VILLAGE OF ANTIOCH

ORDINANCE NO. 12-02-01

AN ORDINANCE APPROVING A PRELIMINARY PLAT OF SUBDIVISION ON THE NORTH SIDE OF ILLINOIS ROUTE 173, IMMEDIATELY EAST OF ILLINOIS ROUTE 83(FILE NO. PZB 11-07)

To: Dustin Nilsen
From: Lee Shannon, III
CC: John Nixon, Jim Keim, Dennis Heimbrodt
Date: November 29, 2011
Re: Plan Review – Plat Approval for Subdivision – IL Route 173 & IL Route 83 – Walgreens – Site Plans Only

A South Elevation

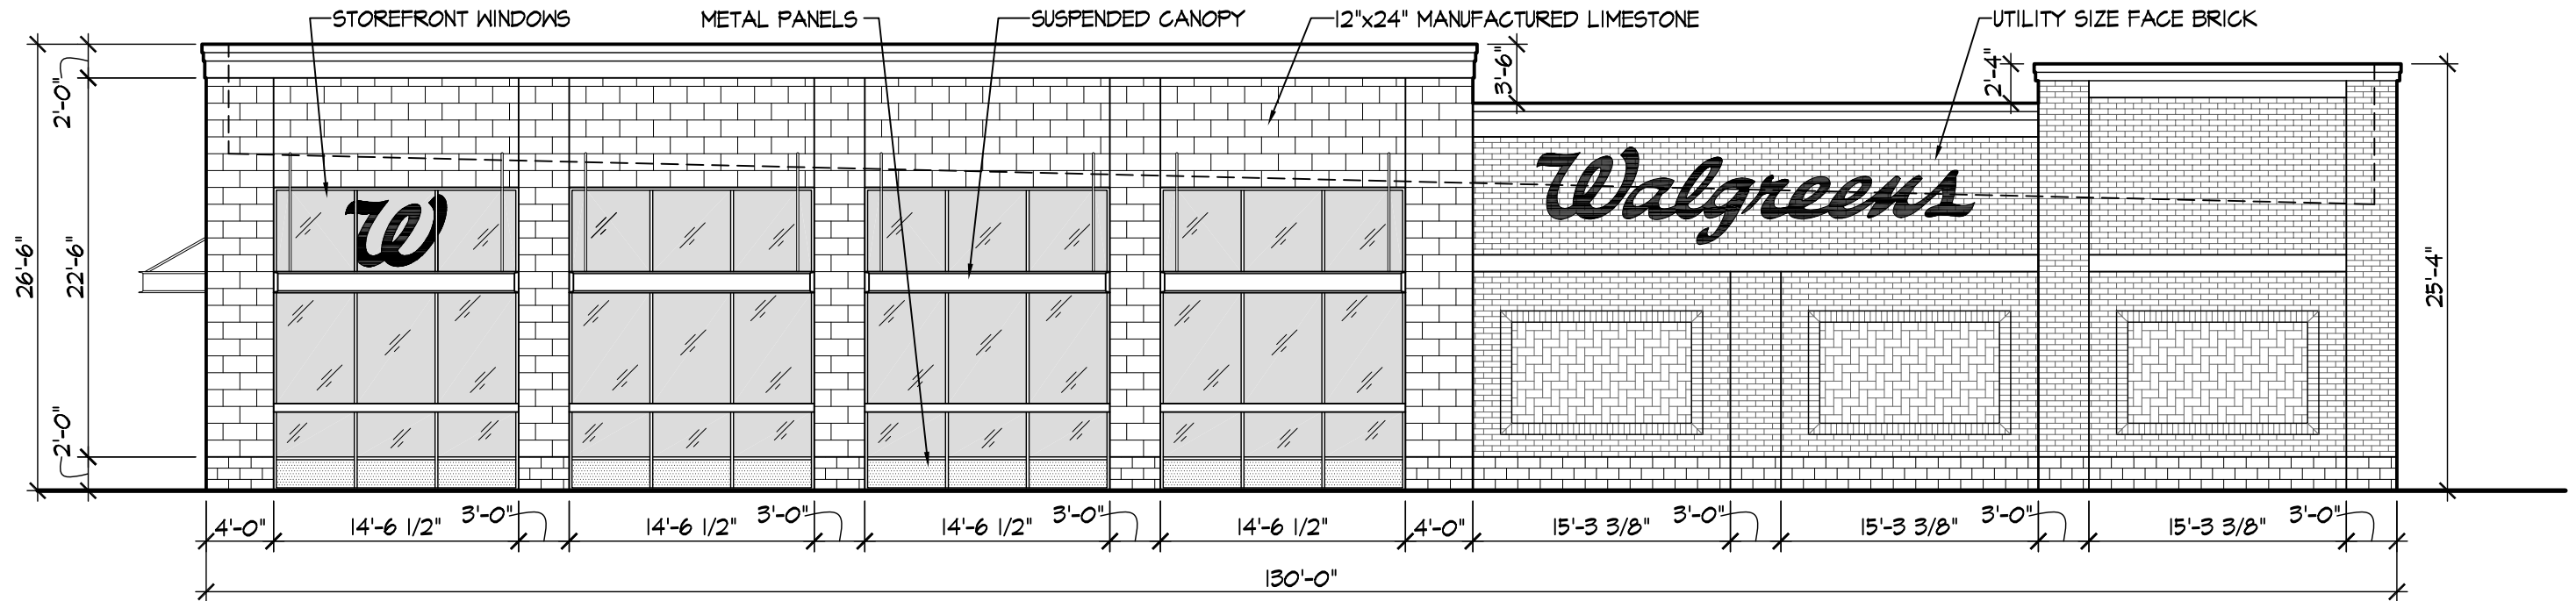
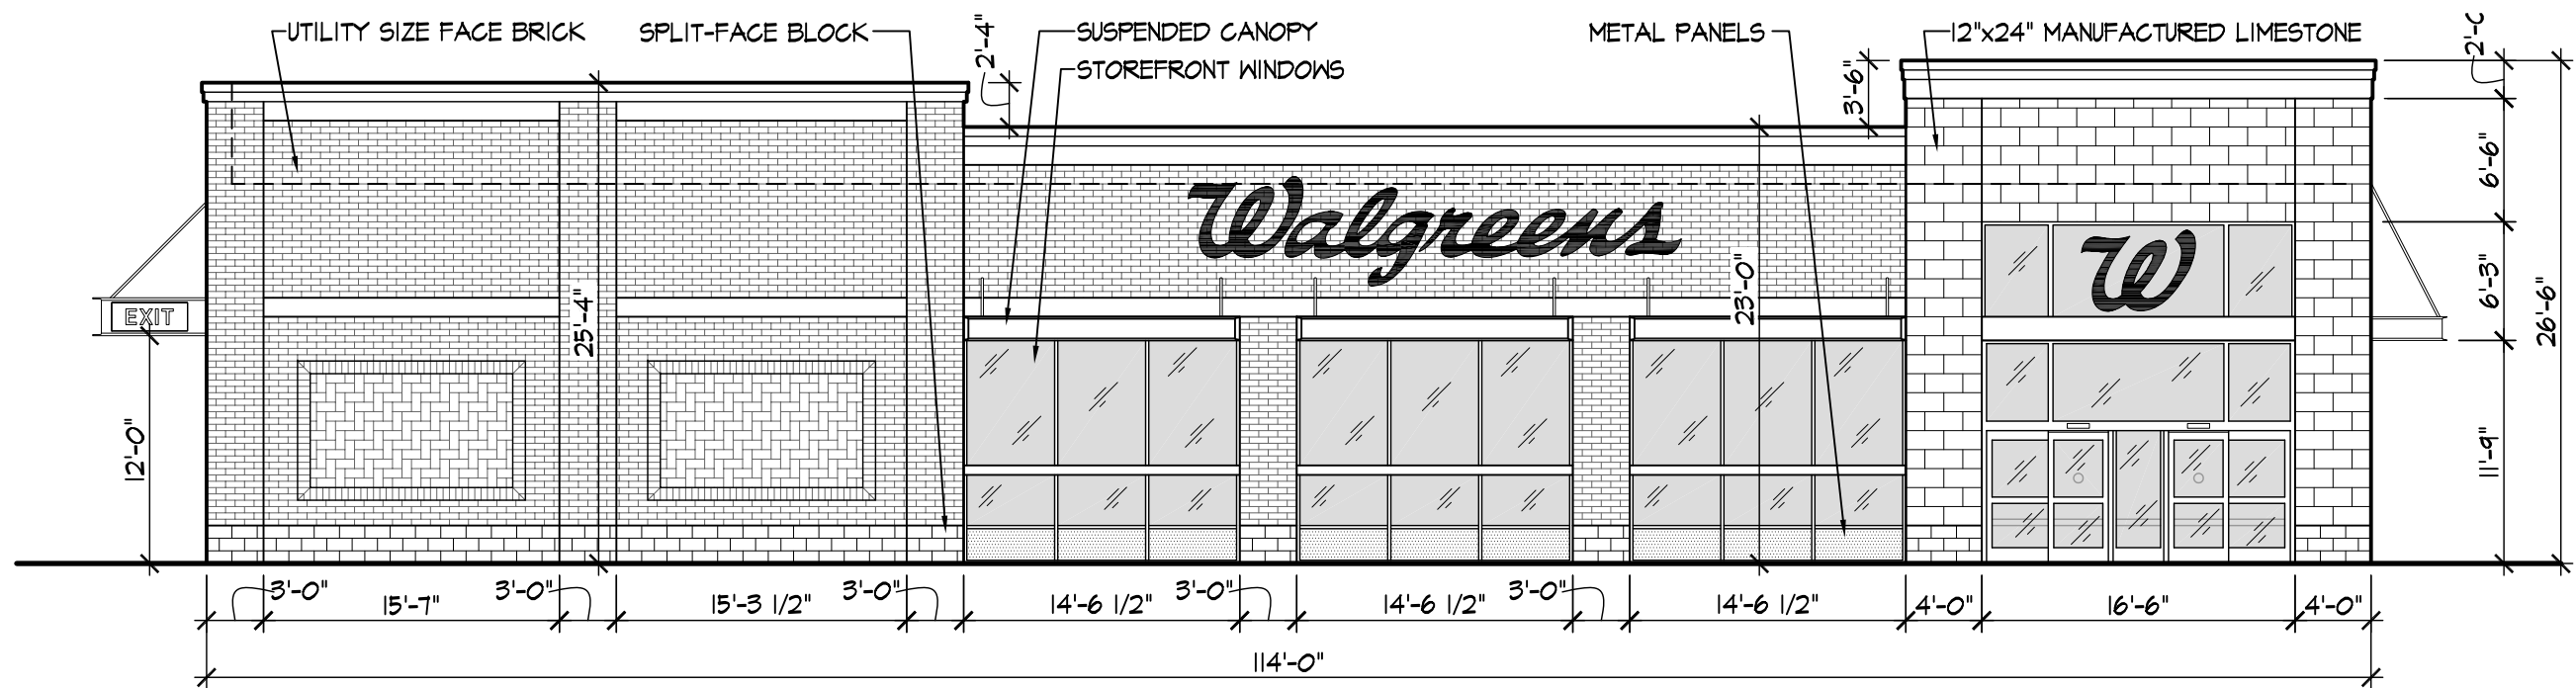
Comment No.1: Provide a suspended steel canopy above the windows on the west and south elevations instead of the cantilevered steel canopy:

Comment No.2: Infill the areas above the windows within the corner element's stone façade with brick:

Comment No. 3: Wrap all parapets back to avoid façade without depth of field:

Comment No. 4: Move stone tower element to southeast corner. Wrap tower and materials around to east façade to match material and mass of entry. Use bay in lieu of glazing at base (More faux entry than Northwest corner).

Response: This has been reviewed with Walgreen's and we agree to make this change. See the updated building elevations and rendered view.

Response: After reviewing this request, we believe that the design is much stronger cladding the corner element completely out of stone as depicted in the rendering. Adding the brick will make the stone elements too thin and will diminish the strength of this element. It is intended to read as a separate massing within the façade and the addition of brick will make this element appear to be a series of thin vertical columns.

Response: We have reviewed this situation and do not believe it is necessary. The cornice element will wrap around the corner and continue to the inside face of the adjacent masonry wall. Extending the wall over the roof will require a significant amount of extra structure for minimal impact.

Response: We have developed a masonry bay expression at the southeast corner to match that of the northwest corner, shifting the wall sign to the west. Walgreens will not allow an entrance element anywhere other than the entrance, which we agree with, and the uses within the store will not allow real glass in this area. The cost for providing a fake window element will push this project over budget. We believe keeping the entrance element four bays wide along the south façade, including the current amount of vision glass, is much stronger and more desirable for the Route 173 frontage. In addition, the location of the trash enclosure along the east wall will interfere with the reading of this element as an entry. We have updated the building elevations and rendering to show this change.

A North Elevation

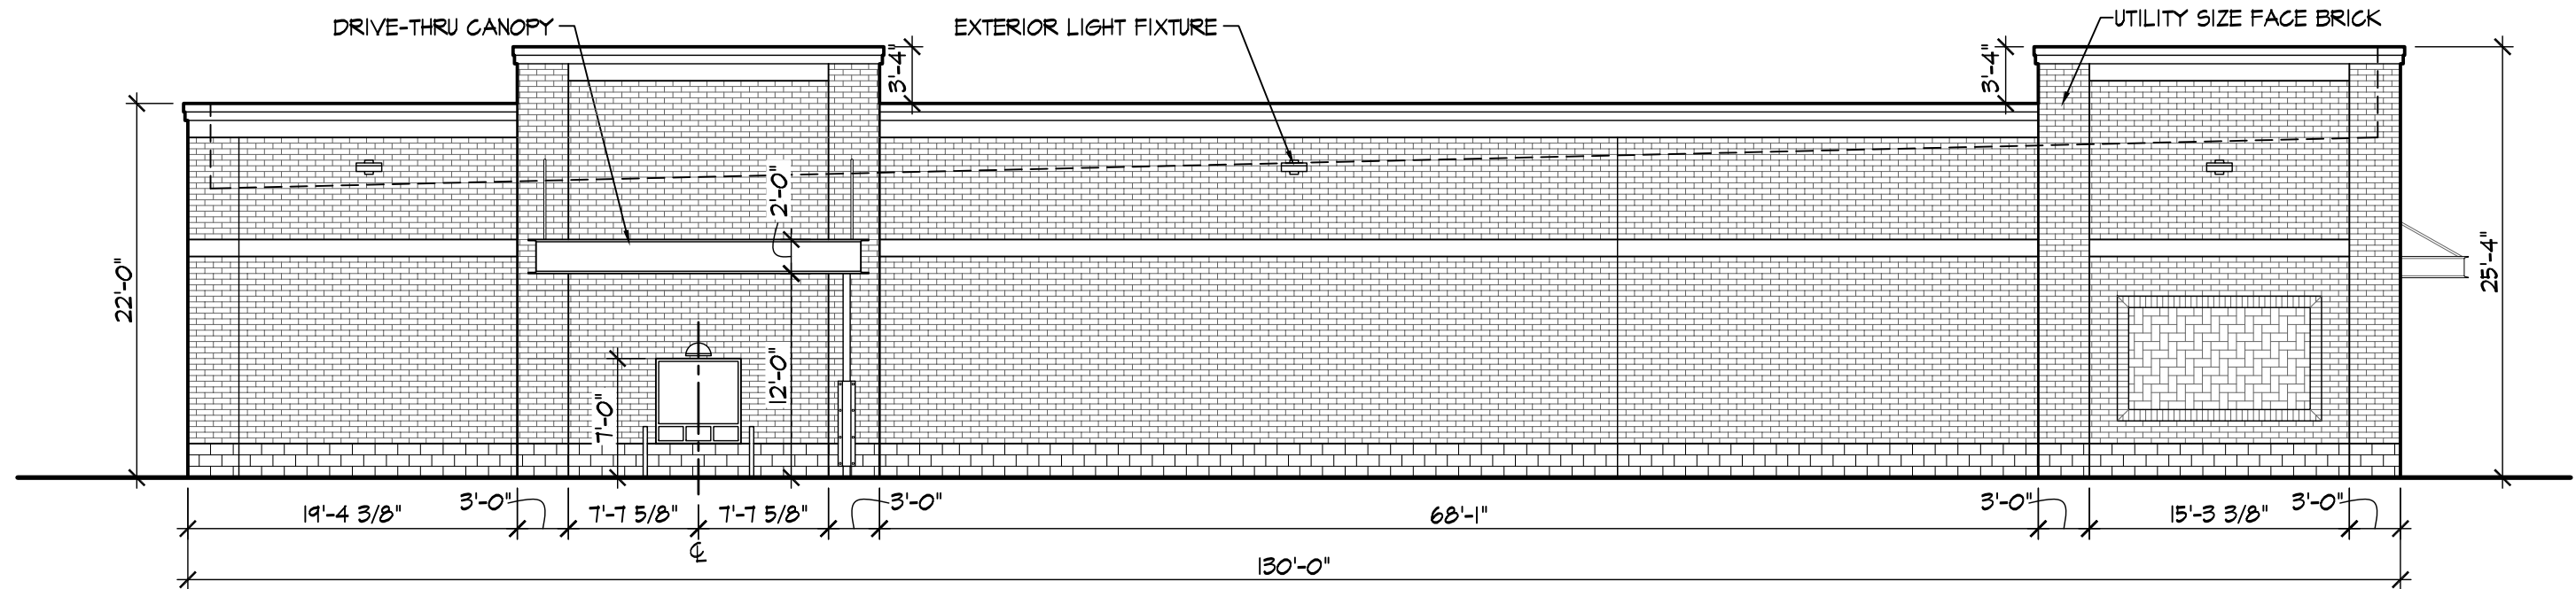
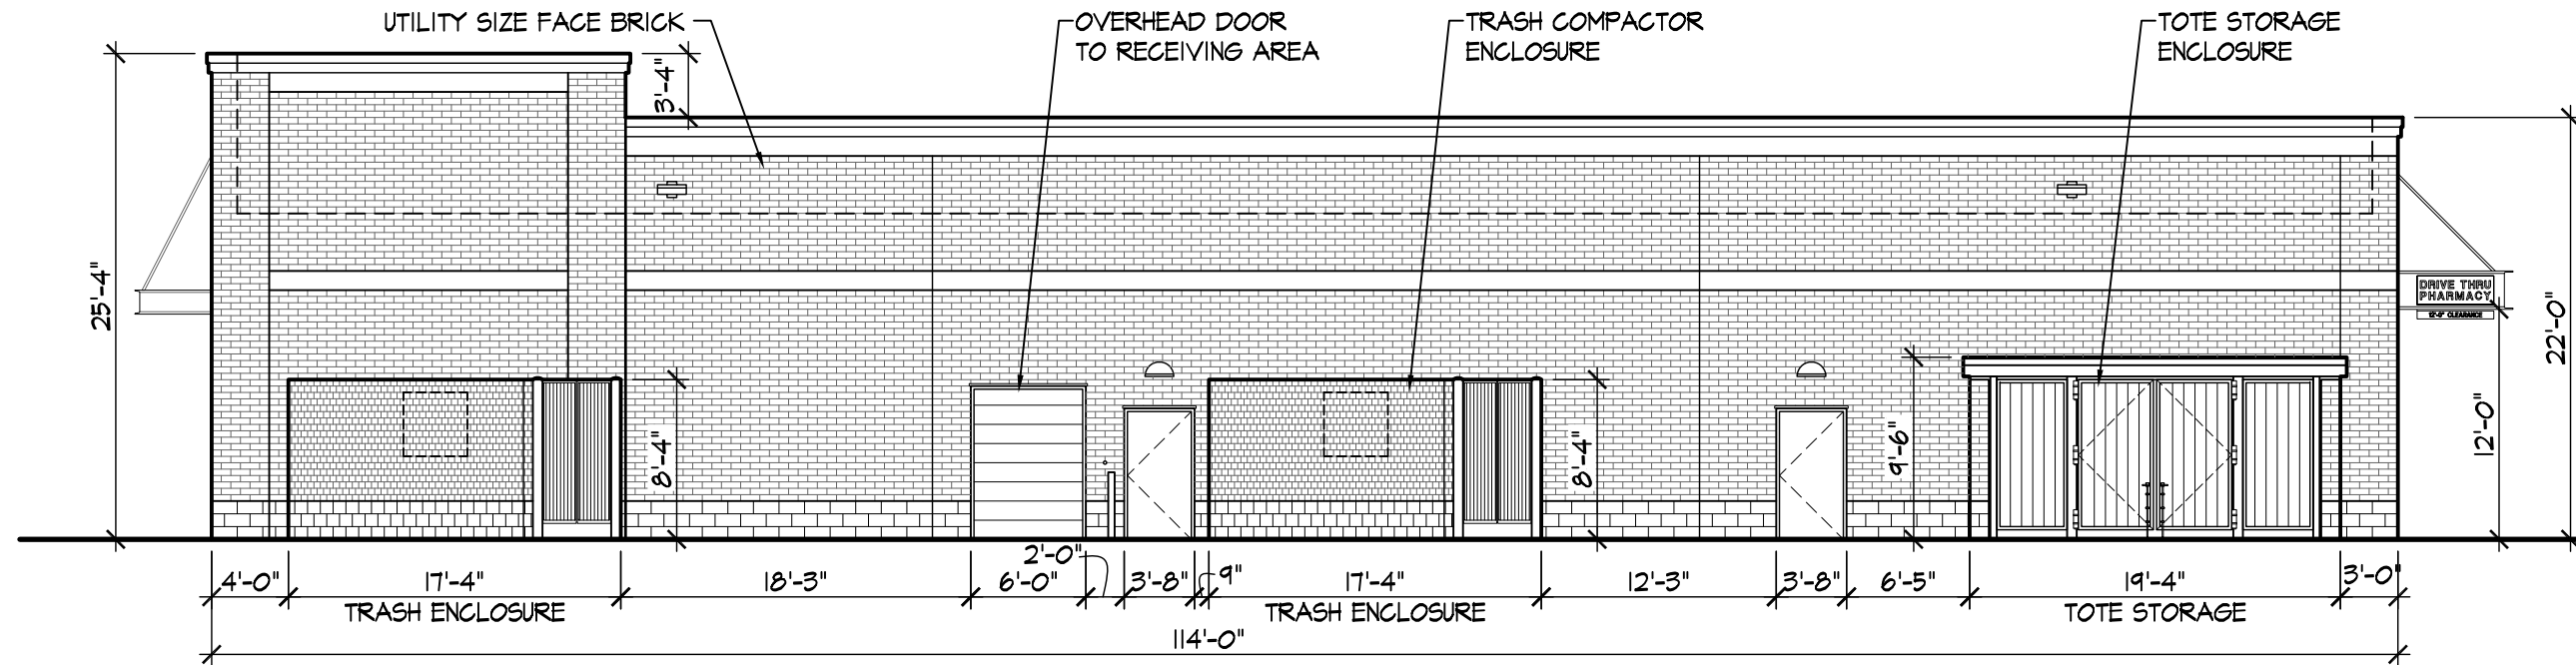
Comment No. 5: Consider pilaster/ column and/or course pattern and wainscoting along the east façade.

Comment No. 6: Eliminate standing seam metal roofing from drive-thru canopy and use suspended canopy similar in style to the canopies on the rest of the building:

Comment No. 6: Provide a material change or bay design at the drive-thru window.

Comment No. 7: Wrap bay from front around to north façade at northwest corner:

Response: We have continued the stone base (wainscoting), stone cornice line and horizontal stone band along the entire length of the east and north facades. We are not showing columns or pilasters since the amount of other elements along these facades (trash, fencing, drive-thru, etc) would make it difficult to establish a regular spacing. We believe the changes we have made meet the intent of your comment.

Response: We agree to this change.

Response: While we do not believe there is a need to do this in a location that is not a corner and that faces the school, we have provided a higher bay expression consistent with the corners of the building at the drive-thru window as requested.

Response: We agree to this change.

1 CONCEPTUAL LANDSCAPE PLAN
SCALE: 1"=20'-0"

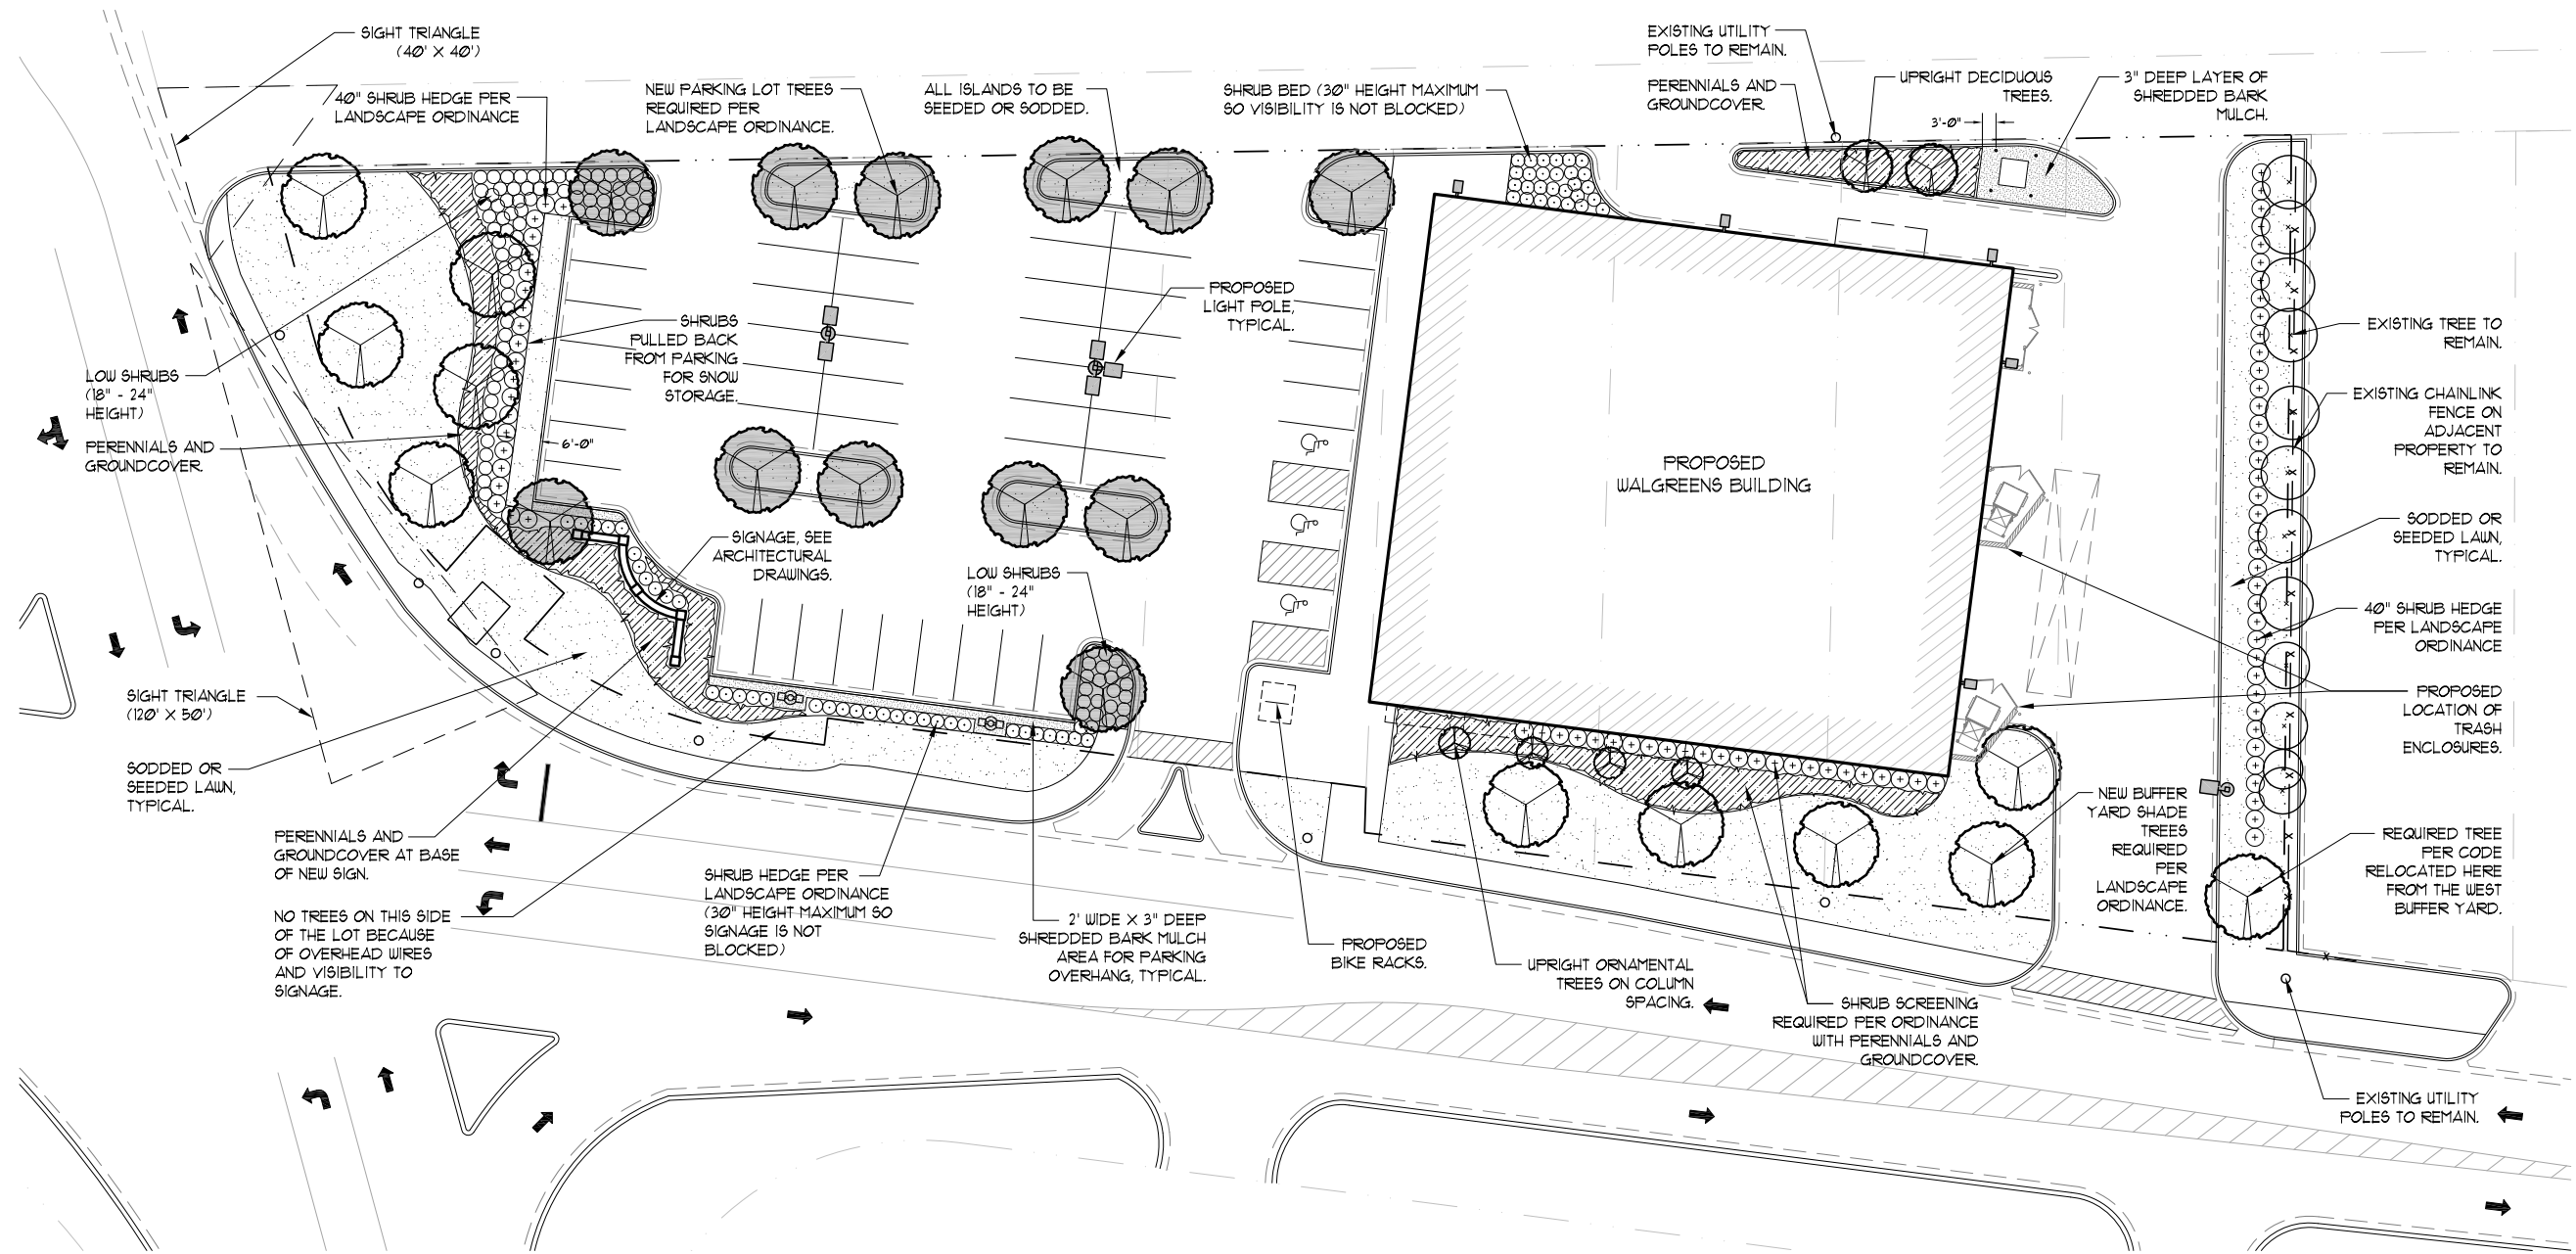
2. Trees are required as part of the landscape ordinance. Most of these trees on the conceptual landscape plan are on islands leading into and out of the parking area. In addition, trees are planned to be located along the south side of the building. Electrical, telephone and cable utilities all are above ground and are located along the north side of IL Route 173 (south side of proposed building).

4. It is typical for all businesses to have their parking lots cleared of snow during the winter months by pushing the snow past the outer perimeter of the parking lot. Based on the Conceptual Landscape Plan, this could pose a problem for pushing the snow past the outer perimeter of the parking area. In addition, if the winter produces a large amount of snow that lingers, snow piles could become sight obstructions along IL Route 173 and also IL Route 83 (Main Street). Being that this intersection is heavily travelled throughout the year, sight obstructions are a great concern.

Please present a snow removal plan that will address concerns of sight obstruction including all entrances and exits around this property including the entrance/exit between this property and the high school entrance to IL Route 83 (Main Street) north of the property.

Comment No. 1: Replace required north hedge (not provided) to 83/173 parking perimeter:

Comment No. 5: Incorporate ornamental trees along the south facade of the building.

Comment No. 6: Provide a table on the landscape plan showing the quantities of code required trees and shrubs and provided trees and shrubs.

Response: Landscape Plan has been adjusted.

Response: This has been done.

Response: This has been provided.

Comment noted, this will be addressed on the final landscape plan.
